PROJECT: Falcon Marketplace
 PROJECT NO: 20988-00CSCV
 DESIGN BY: KGV
 REV. BY: TDM
 AGENCY: El Paso County
 REPORT TYPE: Preliminary
 DATE: 8/31/2018

FALCON MARKETPLACE

EXISTING DRAINAGE CONDITIONS

PROPOSED DRAINAGE CONDITIONS

D-1

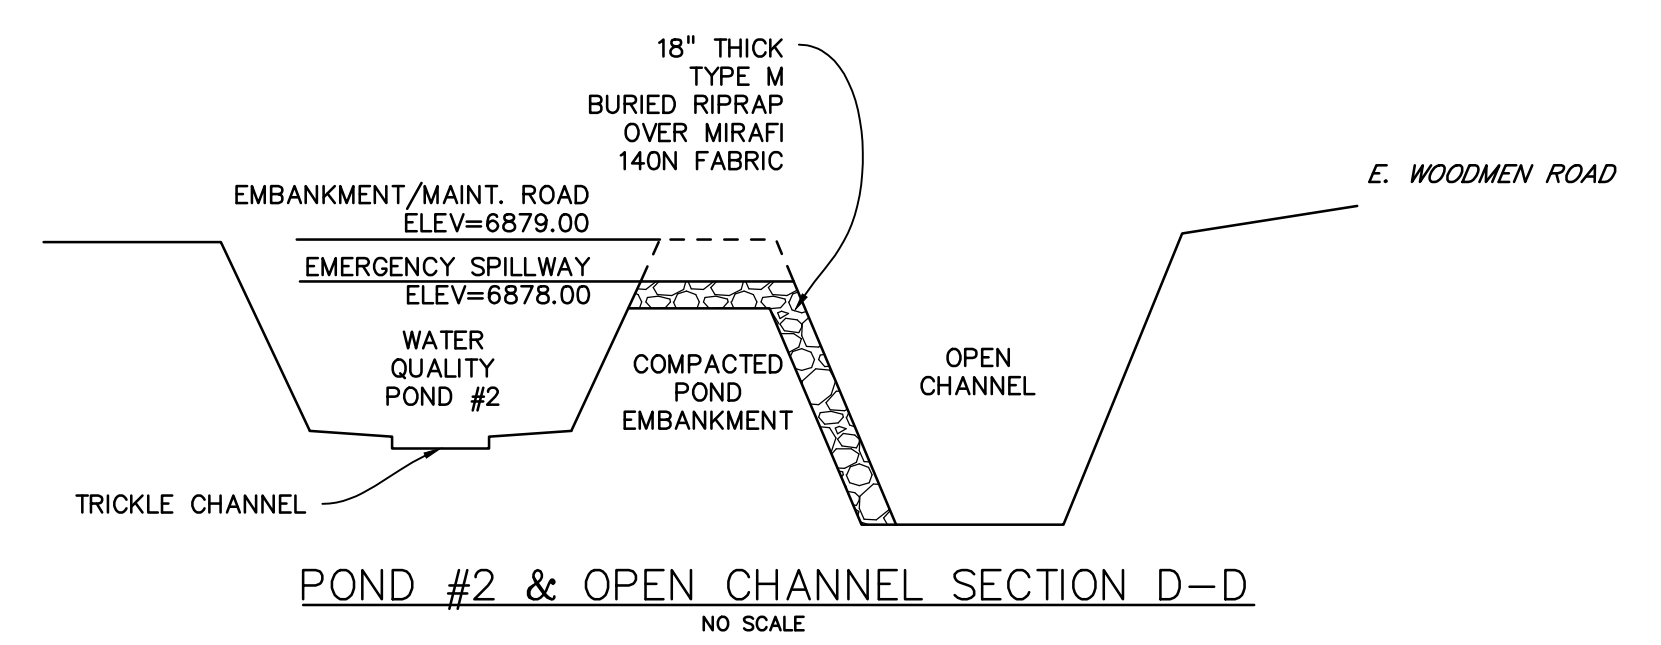
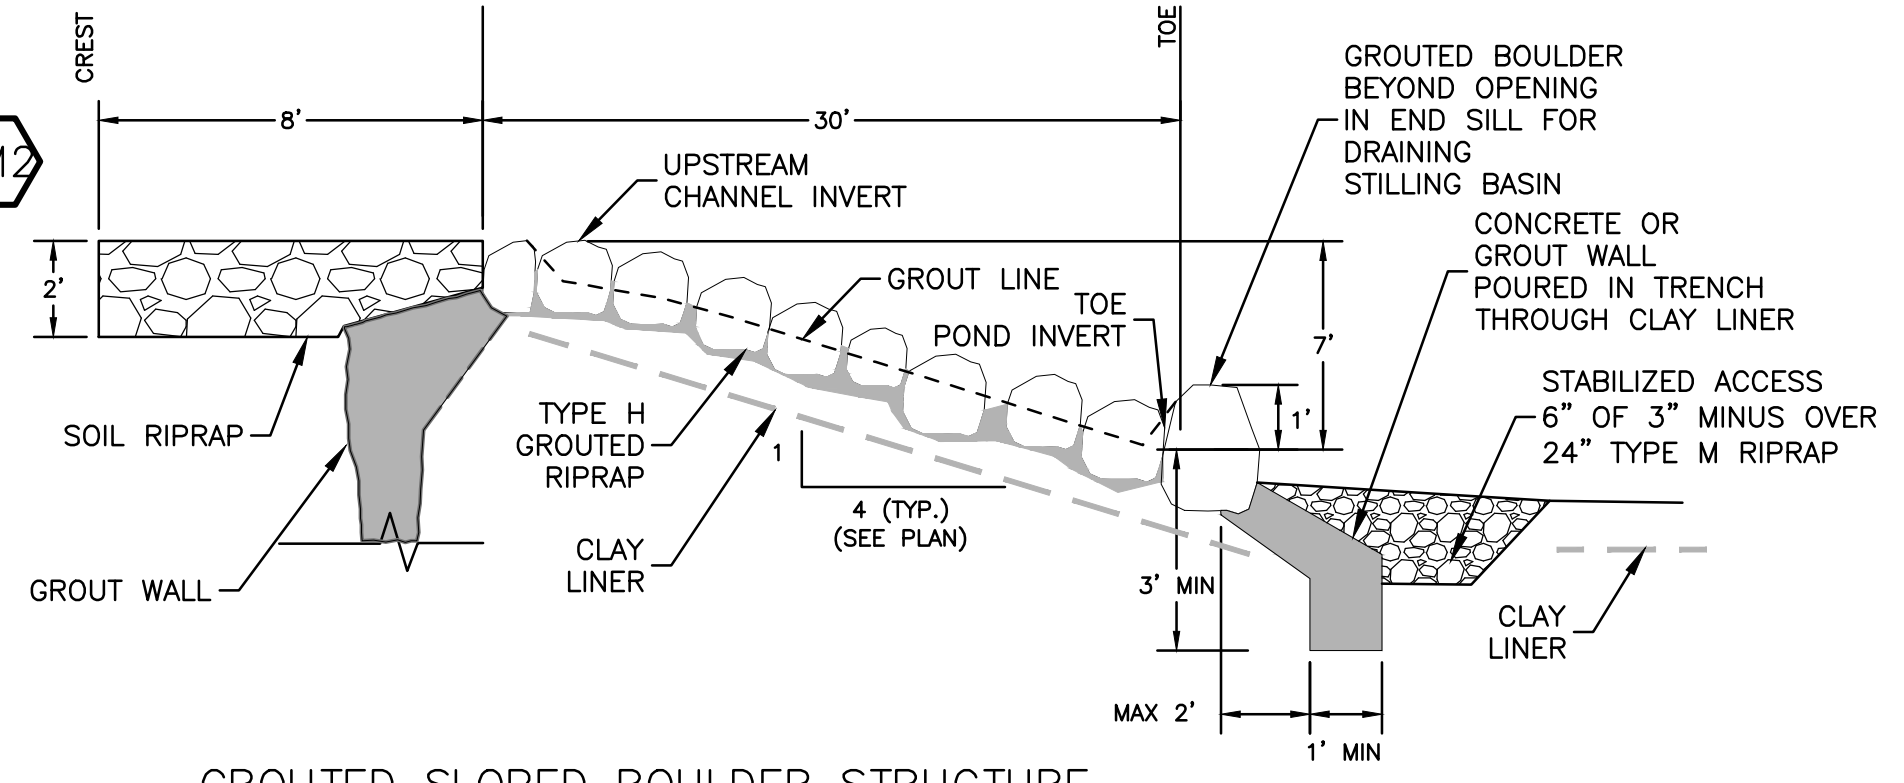
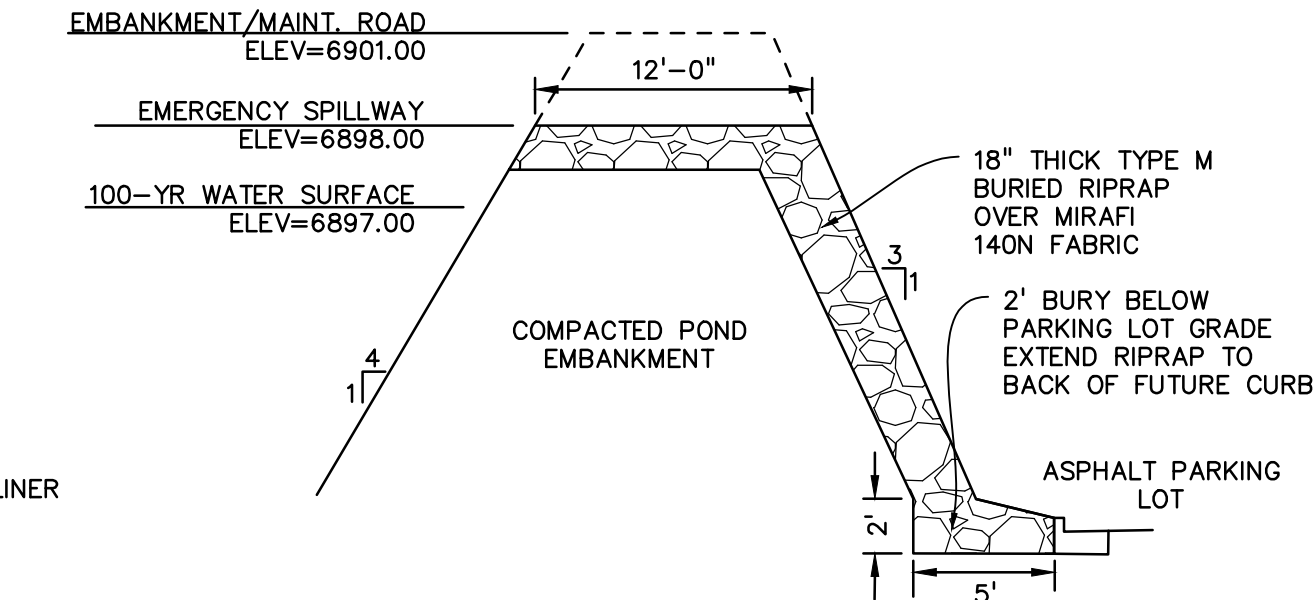
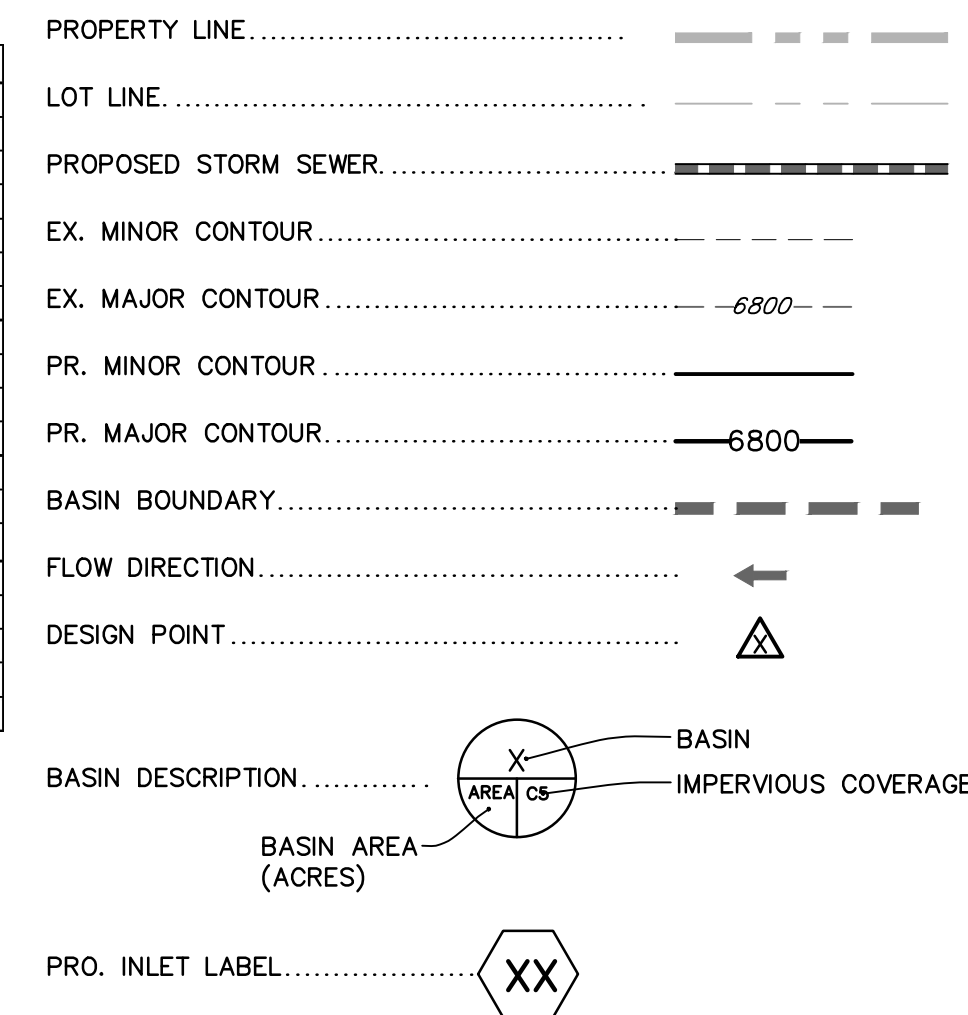
Show and label all offsite design points and sub-basins.

Provide calculations showing width and depth of flows entering pond at all applicable locations.
